Response to Further Information

ABP-320946-24 Outdoor
Amenity Enhancement
Project at Long Point,
Loughrea, Co. Galway

Client: **Galway County Council**

Project Number: **220727**

Figure 3: Extract of Figure 5-3 of the Updated EcIA showing the Scattered Trees and Parkland in Car Park Area B

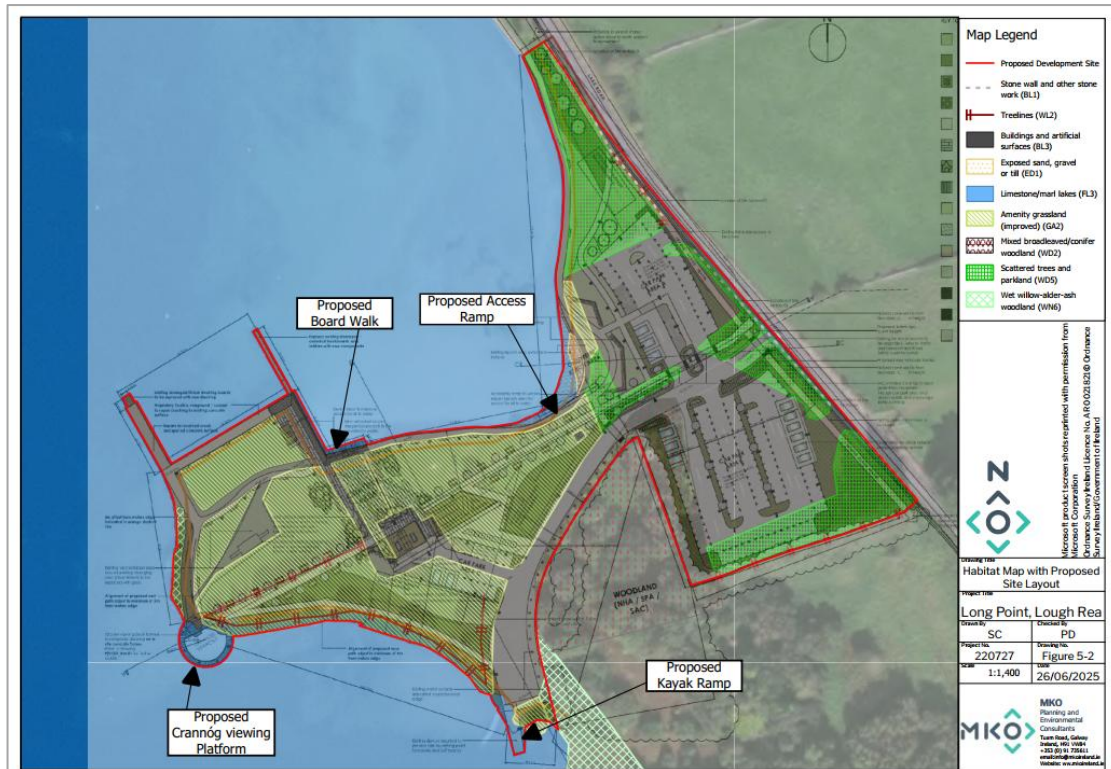
Detailed description of vegetation, including trees to be removed for the creation of proposed car parking area B.

The majority of works to be undertaken are located in highly modified and managed habitats such as buildings and artificial surfaces, amenity grassland, non-native semi-mature treelines, and scattered trees and parkland. This includes both carparks A and B, as well as the amenity areas in the western section of the site. Please refer to **Section 5.1.1 of the Updated EcIA** which includes a detailed description and assessment of the habitats present on the subject site and surrounding area. This response has been informed by a site-specific **Arboricultural Report** which is enclosed as part of the FI response.
